Agenda Item # 18

MOD-003753-2026

- Modification of a previously approved Planned Unit Development.

APPLICATION NUMBER	18	DATE	July 16, 2026
APPLICANT	Lukas Benedetto, Piazza Kitchen & Patio		
REQUEST	PUD Modification

DETAIL SITE PLAN

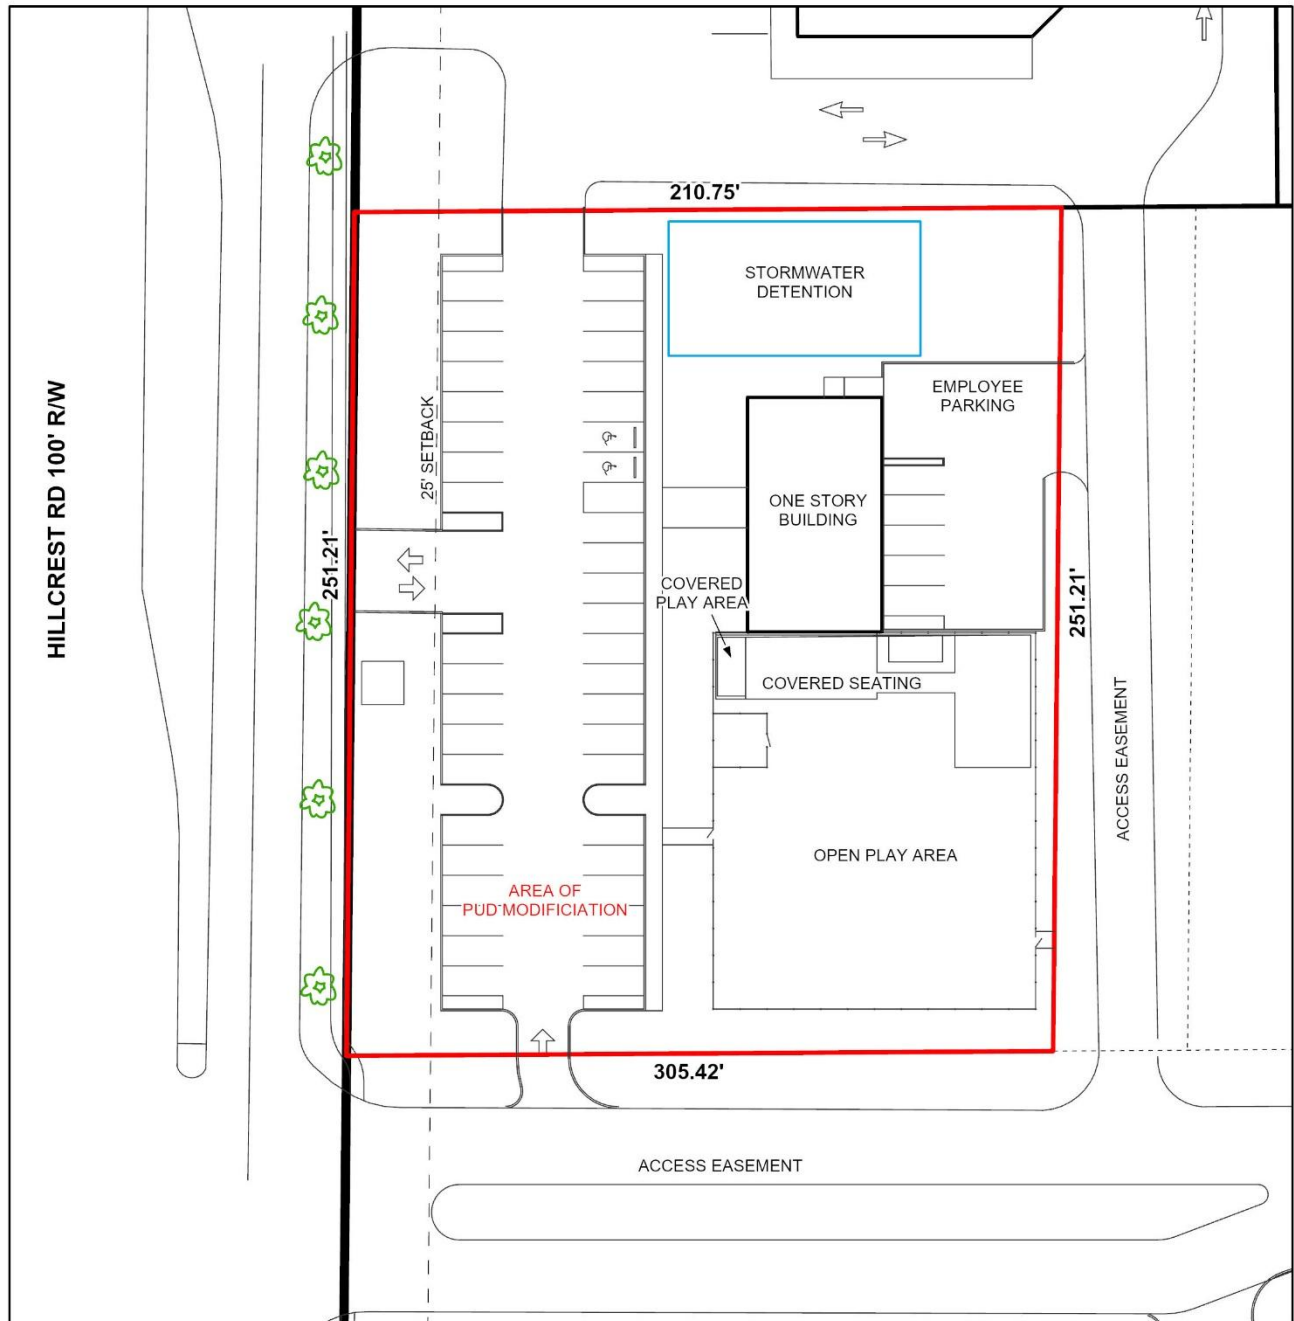
The proposed site plan depicts access to the site via a direct curb cut onto Hillcrest Road, a curb cut connecting to the existing CVS parking lot to the north, and a curb cut connecting to the existing shared driveway to the south. The applicant has submitted authorization from the owner of the CVS property; therefore, the proposed shared access arrangement is permissible.

The submitted site plan depicts a 2,797-square-foot restaurant building, a 2,006-square-foot covered seating area, and both covered and open play areas. Based on the proposed development, a minimum of 17 parking spaces is required. The site plan provides 49 parking spaces, exceeding the minimum requirement by 32 spaces.

Pursuant to the Unified Development Code (UDC), parking spaces provided in excess of the minimum required parking on sites greater than one (1) acre must utilize alternative surfacing. Accordingly, 32 of the proposed parking spaces must comply with this requirement.

Article 3, Section 64-3-12.B., of the UDC requires restaurants to provide off-street loading facilities. Based on the size of the proposed building, one off-street loading space is required. The loading space must be at least 10 feet wide, 20 feet long, and provide a minimum overhead clearance of 10 feet. It is unclear from the submitted site plan whether a compliant loading space is proposed; therefore, any revised site plan should clearly depict an off-street loading space meeting the requirements of Section 64-3-12.B.

Section 64-3-7.A.3.(2)c. of the UDC requires one 9-foot-by-18-foot landscape island for every 12 contiguous parking spaces. The submitted site plan does not appear to demonstrate compliance with this requirement and should be revised accordingly.

No dumpster or dumpster pad is clearly depicted on the site plan. Any dumpster proposed for the site must comply with the enclosure and placement requirements of Article 3, Section 64-3-13.A.4., of the UDC and should be shown on the Final PUD Site Plan. Alternatively, a note may be provided indicating that curbside waste collection will be utilized.

1. Revision of the site plan to depict one (1) nine-foot (9') by eighteen-foot (18') landscape island for every twelve (12) contiguous parking spaces, in compliance with Section 64-3-7.A.3.(2)c. of the UDC;

2. Revision of the site plan to clearly depict one (1) off-street loading space meeting the requirements of Section 64-3-12.B. of the UDC;
3. Revision of the site plan to either clearly depict a dumpster and compliant enclosure in accordance with Section 64-3-13.A.4. of the UDC, or provide a note stating that curbside waste collection will be utilized;

4. Compliance with the alternative surfacing requirements of the UDC for all parking spaces provided in excess of the minimum required parking;
5. Submission of a photometric lighting plan demonstrating compliance with Section 64-3-9.C. of the UDC at the time of permitting;
